## Planning Commission Staff Report

**Project Type:** Site Development Section Plan

**Meeting Date:** May 29, 2013

**Description:** **Spirit Valley Business Park, Lot 1A (Pets and Company):** A Site Development Section Plan, Landscape Plan, Lighting Plan, Architectural Elevations and an Architect's Statement of Design for a 1.502 acre tract of land zoned "PI" Planned Industrial District located on the west side of Spirit Valley Central Drive, south of Olive Street Road.

**LANDSCAPE PLAN**  
SCALE 1" = 20'

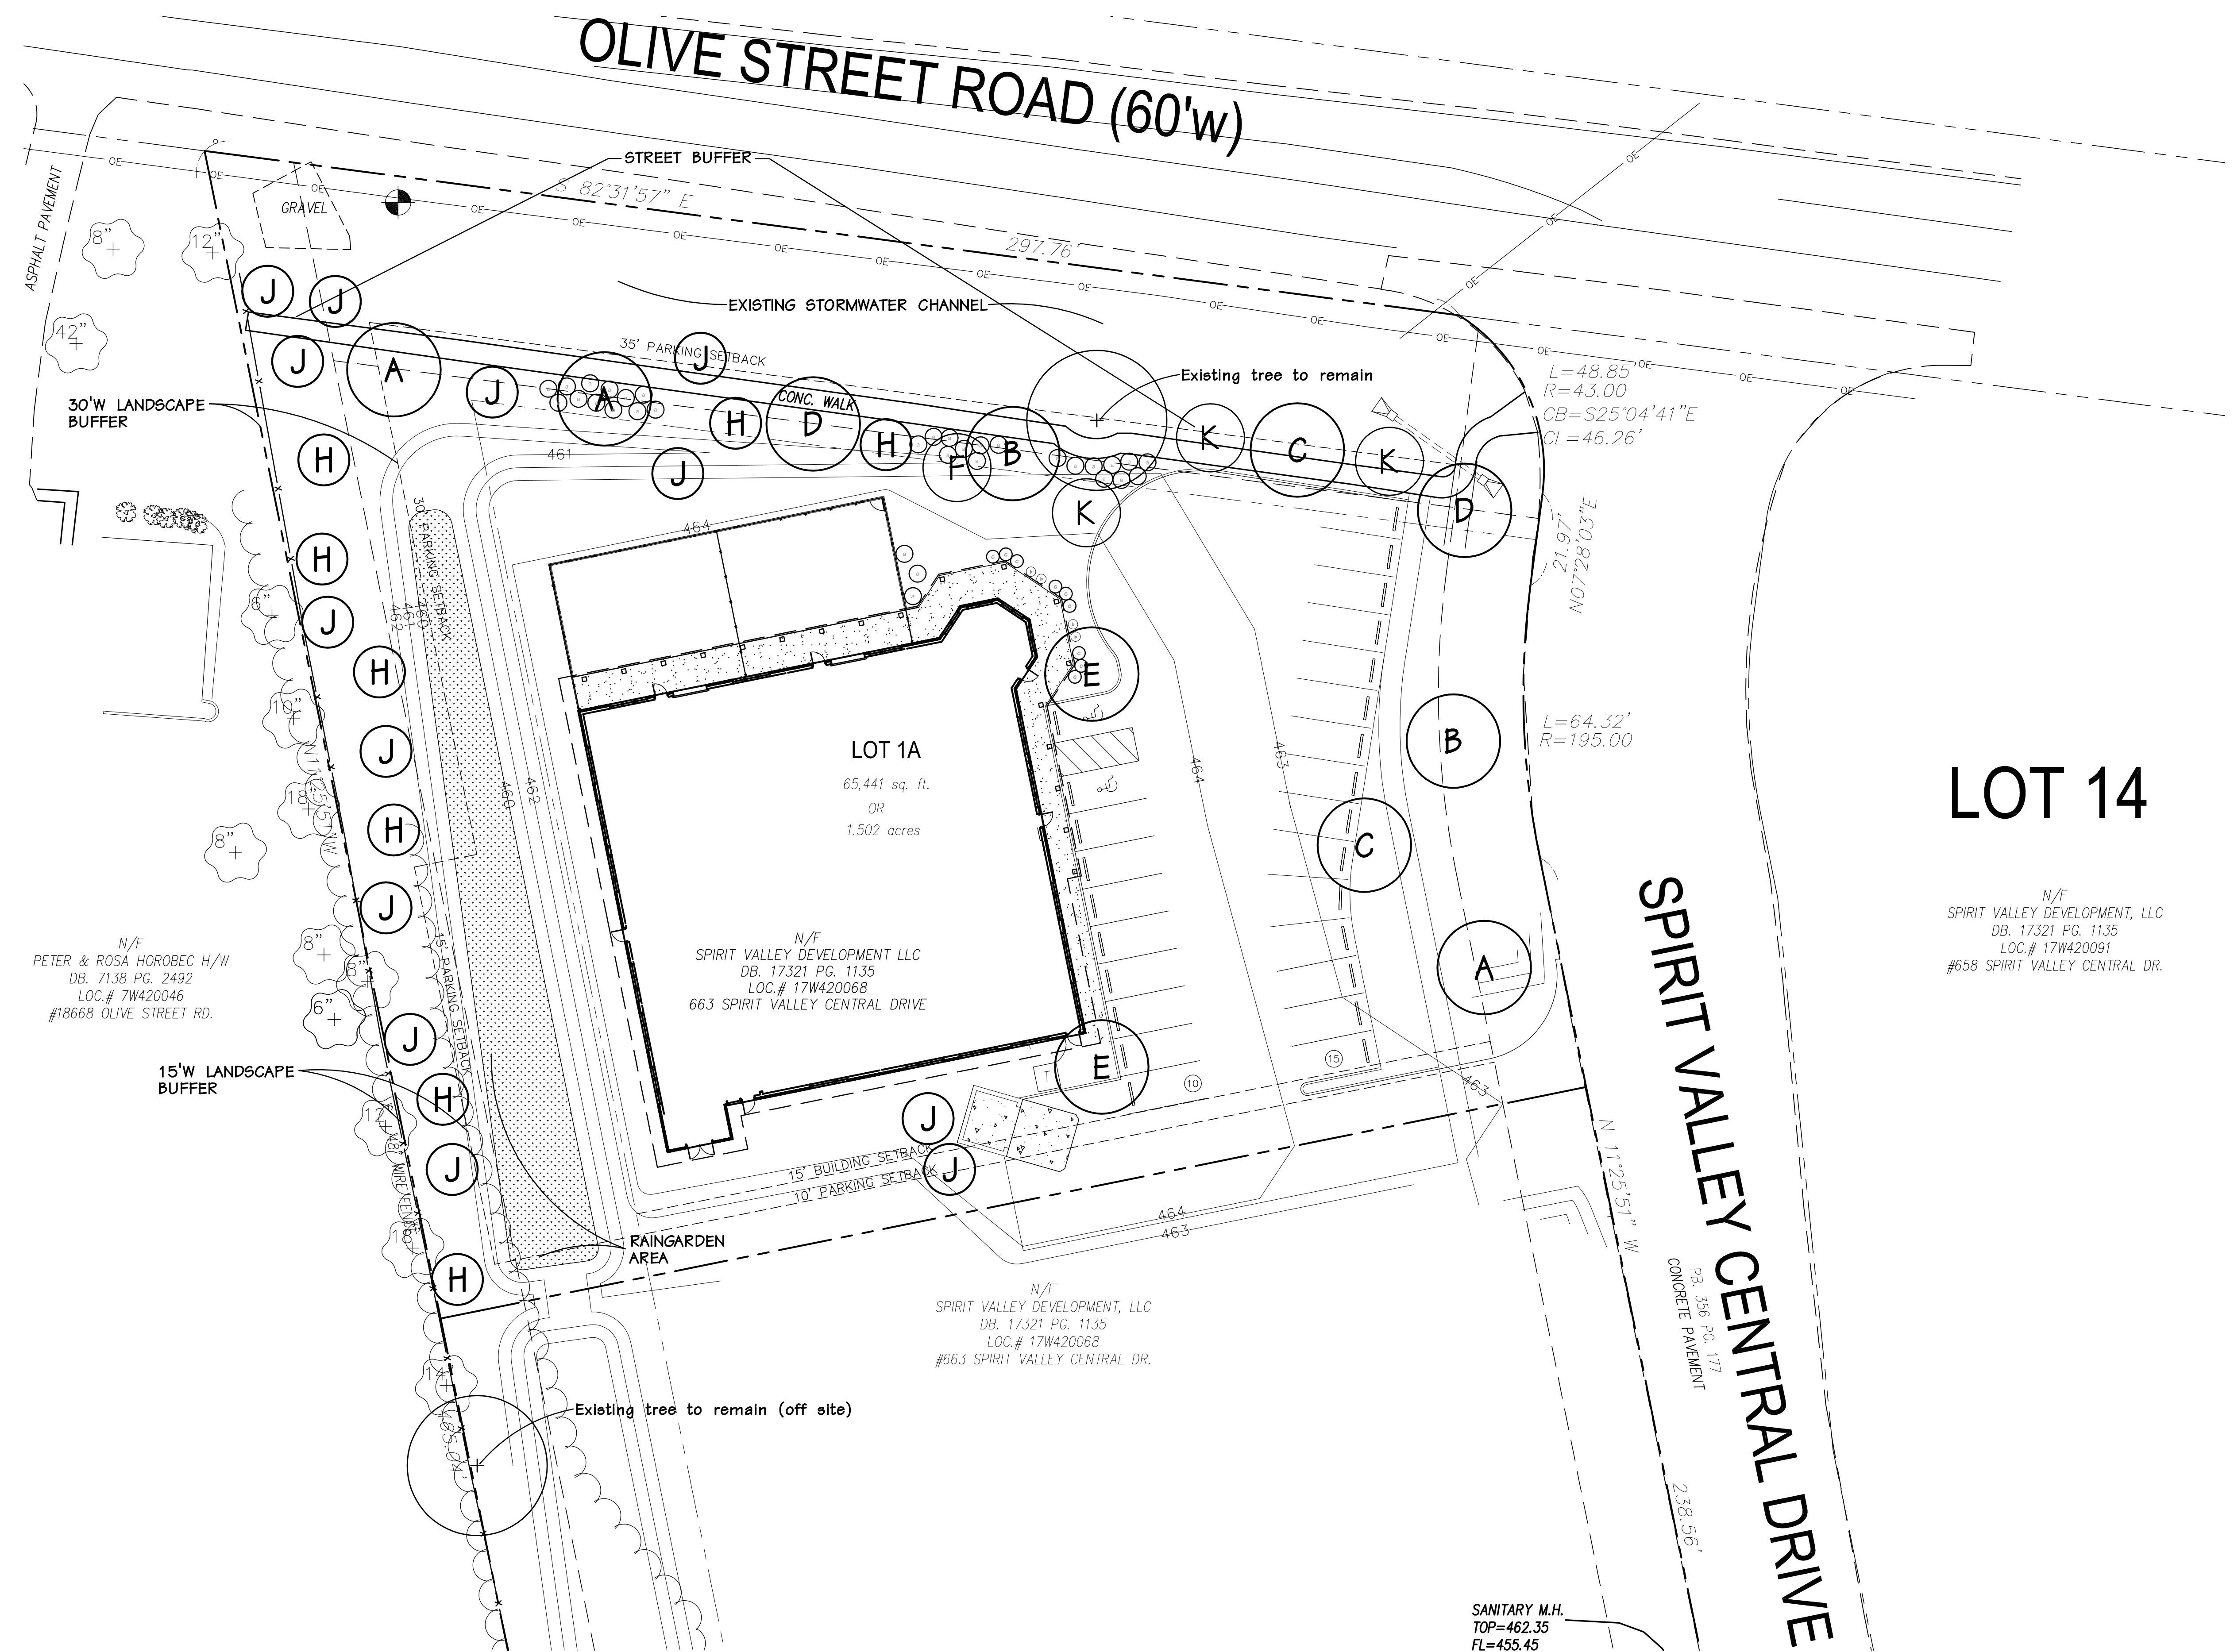
2. *Encourage planting additional shrubbery at the entryway and along the dog play areas.*

The rendering showed some additional low plantings that were not included in the Landscape Plan and therefore the Board suggested adding some low plantings similar to what was shown on the rendering to help soften the appearance of the building.

The applicant has added landscaping along the front entrance of the building and the dog play area as shown in the rendering presented to the Architectural Review Board.

**1 EAST ELEVATION**  
 Scale: 1/8" = 1'-0"

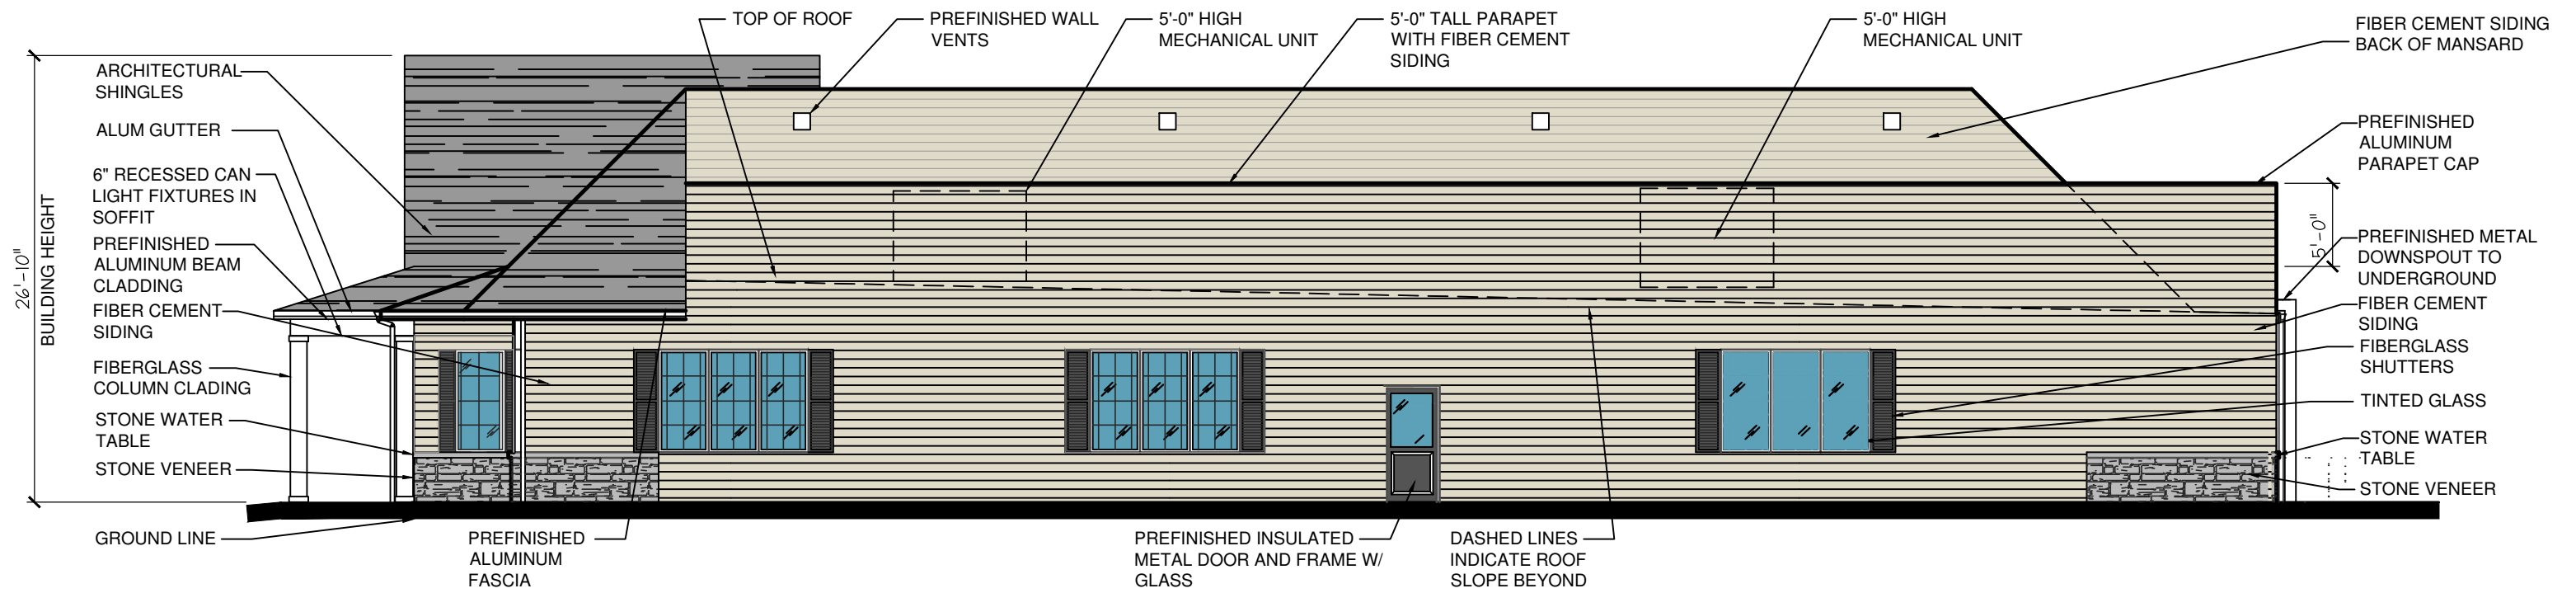
1. *Extend the horizontal stonework along the entire eastern elevation.*

The Board noted that the proposed stone veneer on the east elevation stopped at awkward and arbitrary points on a highly public façade of the building, as it faces the internal drive. The Board recommended carrying the stone veneer continuously across the elevation.

To address this issue, the project now includes a continuous stone veneer accent along the eastern elevation.
